ADDENDUM NO. 1

TO THE CONTRACT DOCUMENTS FOR BULK AIRCRAFT STORAGE HANGAR KEYSTONE HEIGHTS AIRPORT

August 23, 2019
FAA No. N/A, FDOT FM No. 434911-1-94-17
AECOM PROJECT NO.: 60589661

SHEET TITLE
**INDEX OF DRAWINGS &
SUMMARY OF QUANTITIES**

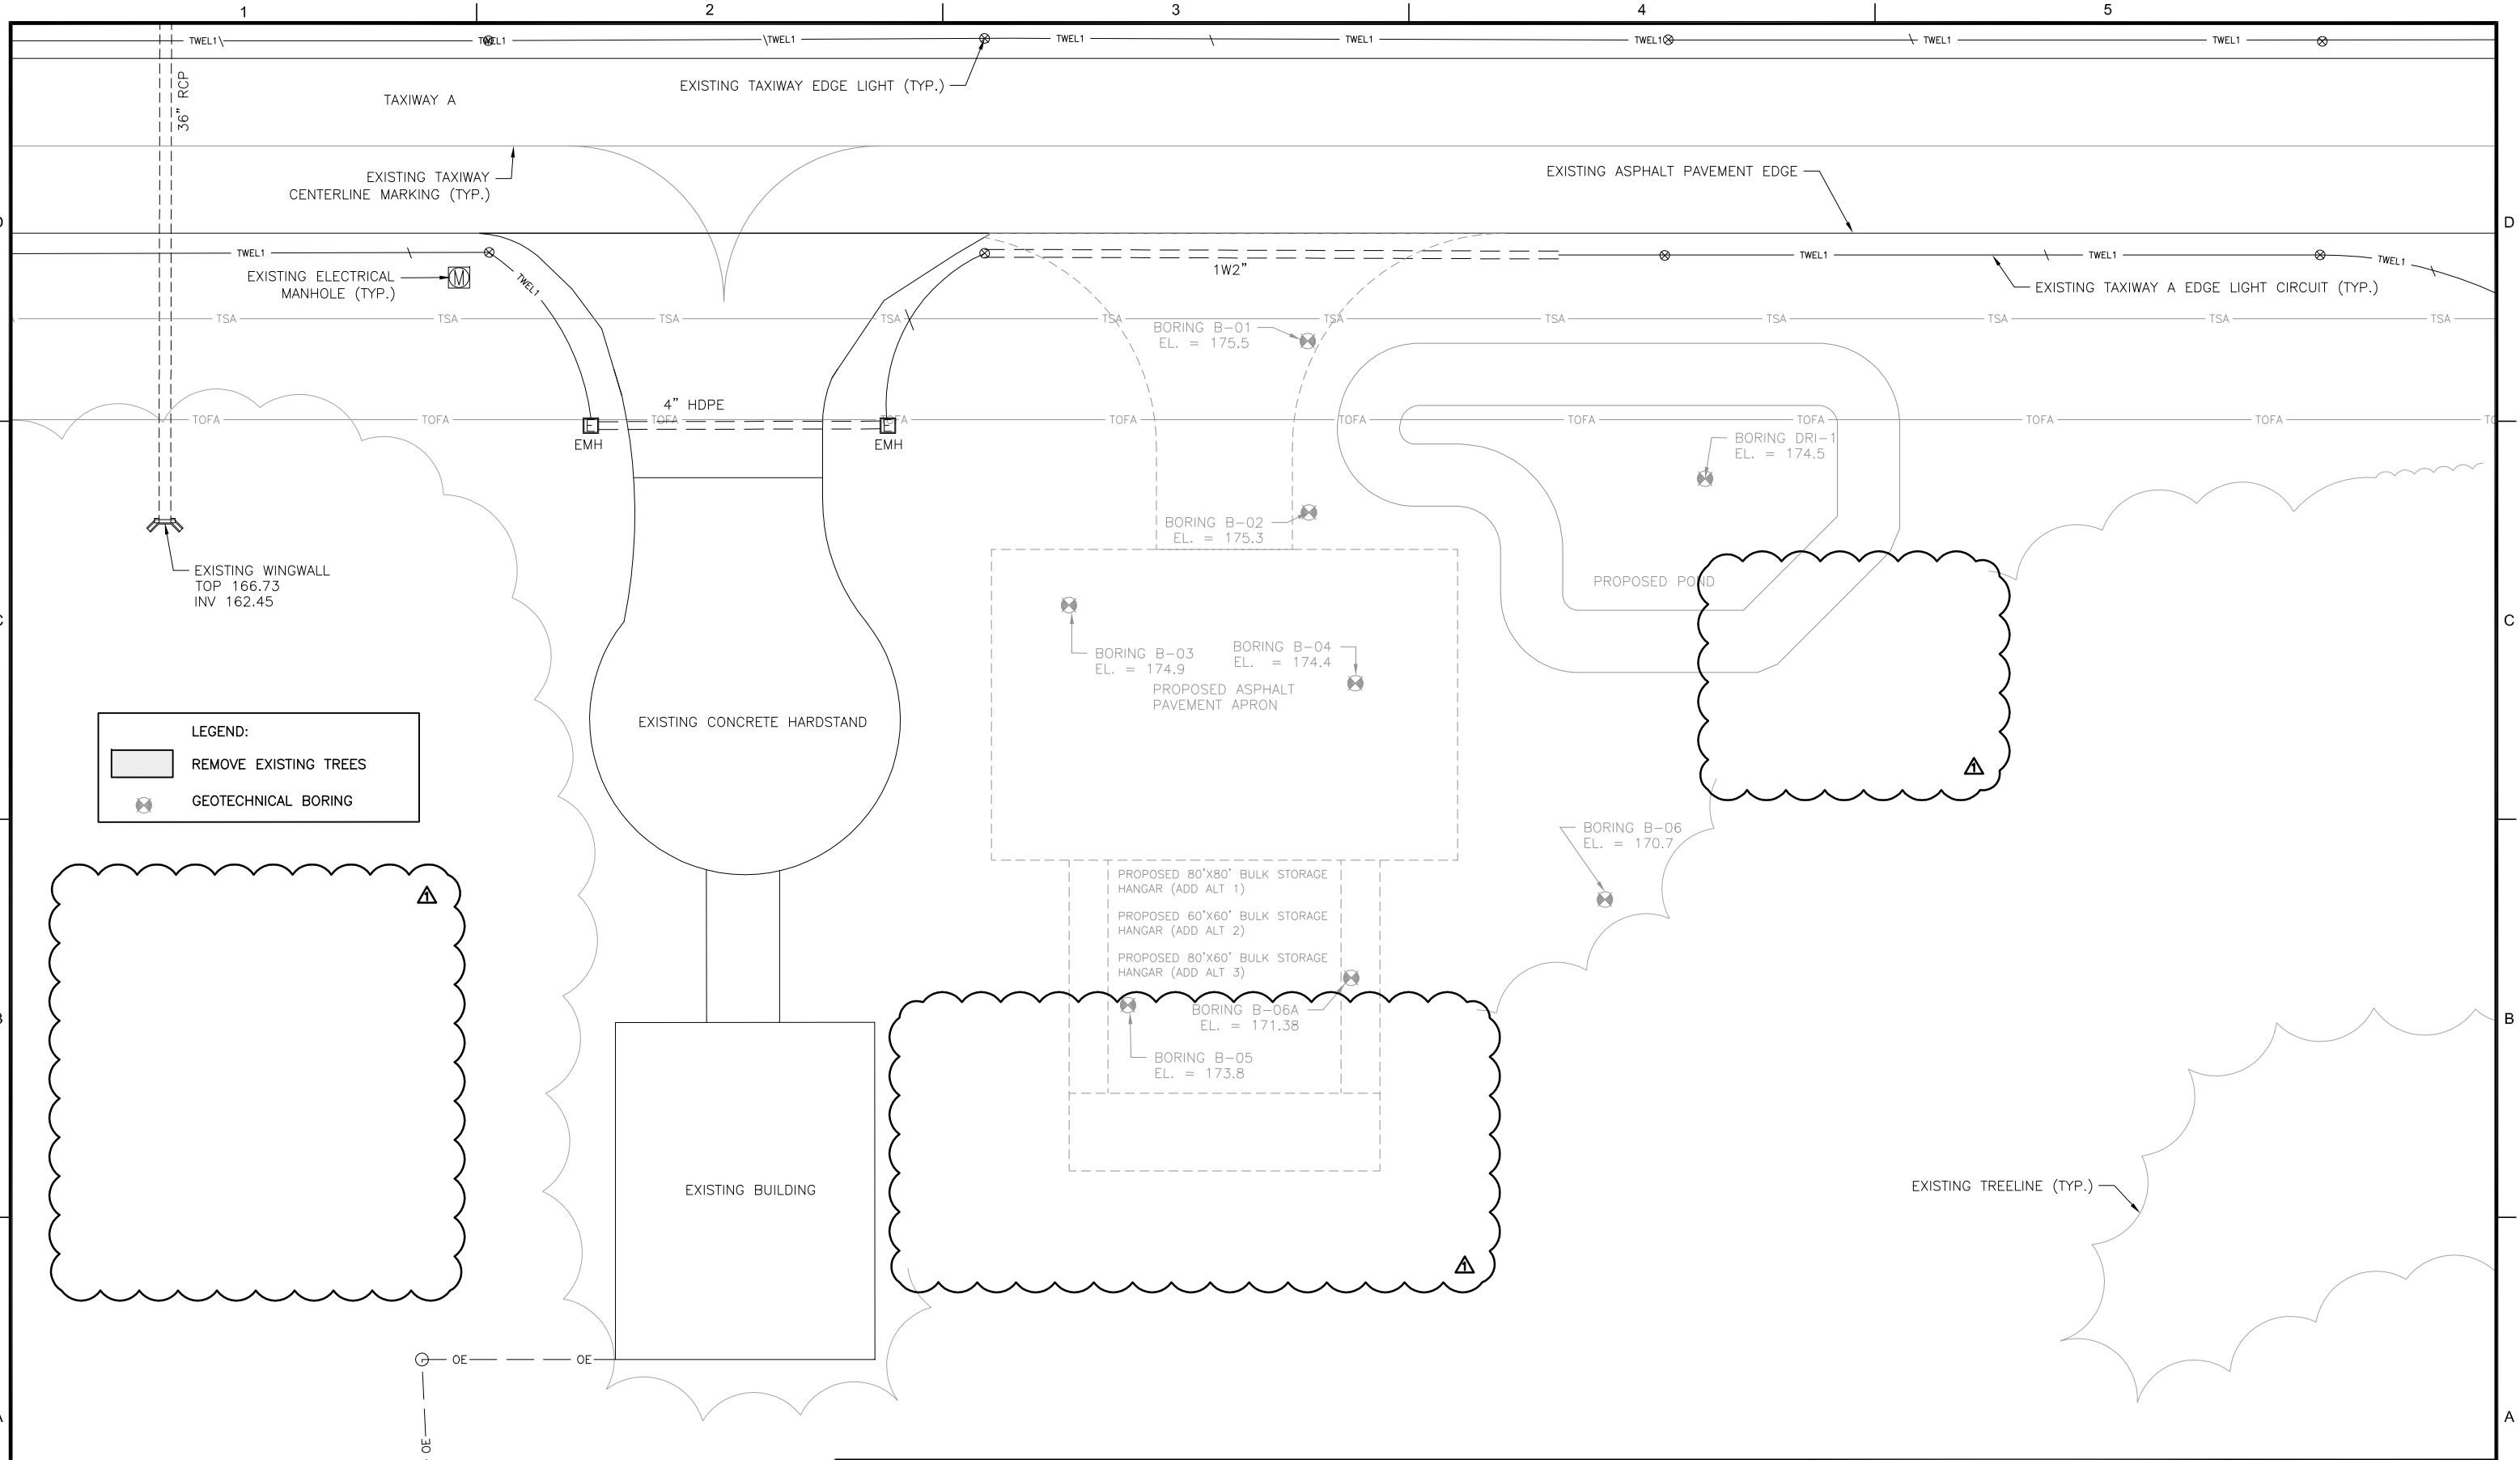
Q3. "I have taken off the 6" ADS and only come up with 370 lf and the bid schedule shows 970 lf."

A3. 370 LF of 6" ADS pipe is correct. The Bid forms have been corrected.
